PROJECT
SERGY BOY
 CLIENT
SARGON BETERAMIA
 ADDRESS
15 WILLIAMS STREET, MELBOURNE

TITLE	JOB NO.	CHECKED
PROPOSED GENERAL FLOOR PLAN/ EQUIPMENT	1907	CK
SCALE	1:100@A2	
DRAWING No.	A101	
REVISION	B

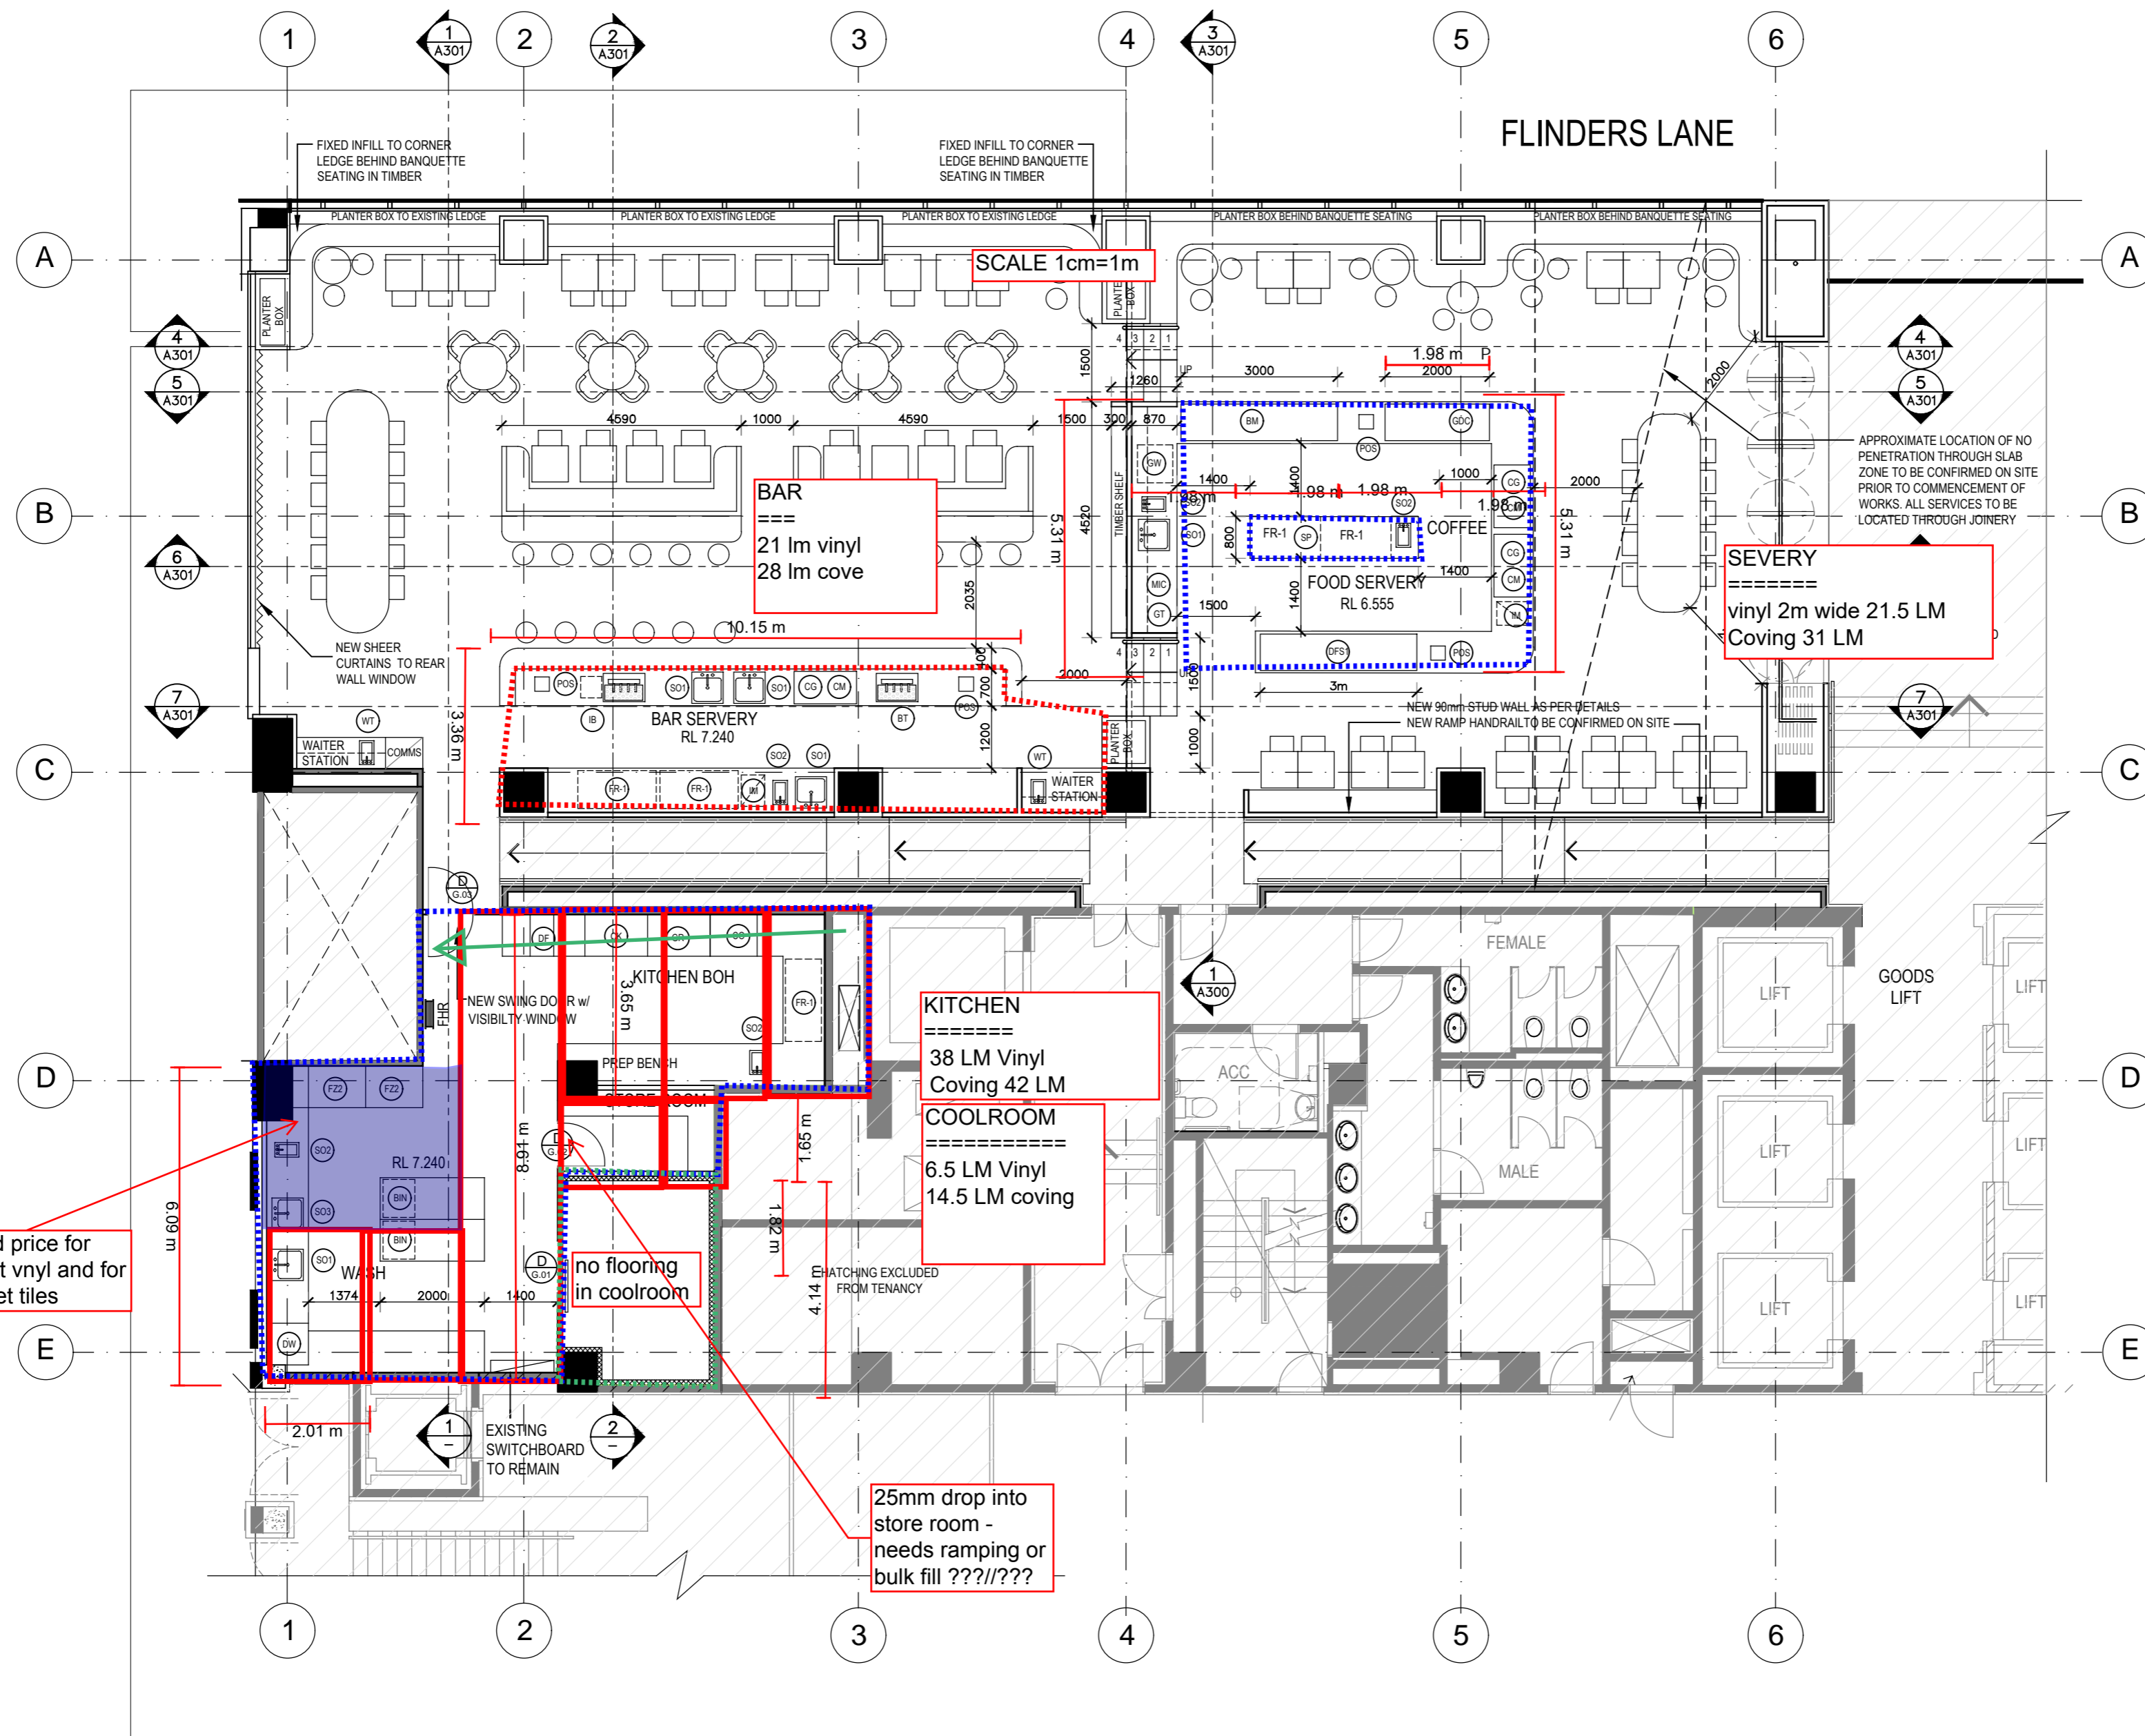
Need price for sheet vinyl and for carpet tiles

25mm drop into store room - needs ramping or bulk fill ???/???
